STAFF REPORT

SUBJECT: ZB #223-43 Special Permit, 375 Fairfield Avenue

APPLICANT: 375 Fairfield Avenue Associates

Building A

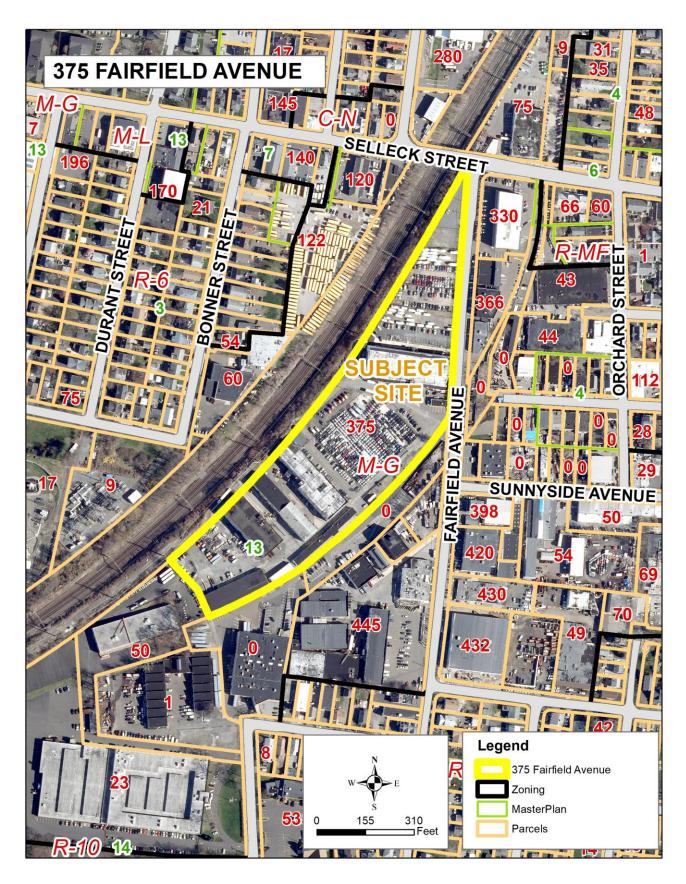
The building is designed in traditional industrial style with glass windows, precast concrete panels and metal panel accents. The entrance area is highlighted by a setback and awnings. The large window bays and multiple entrances help break the façade on each side.
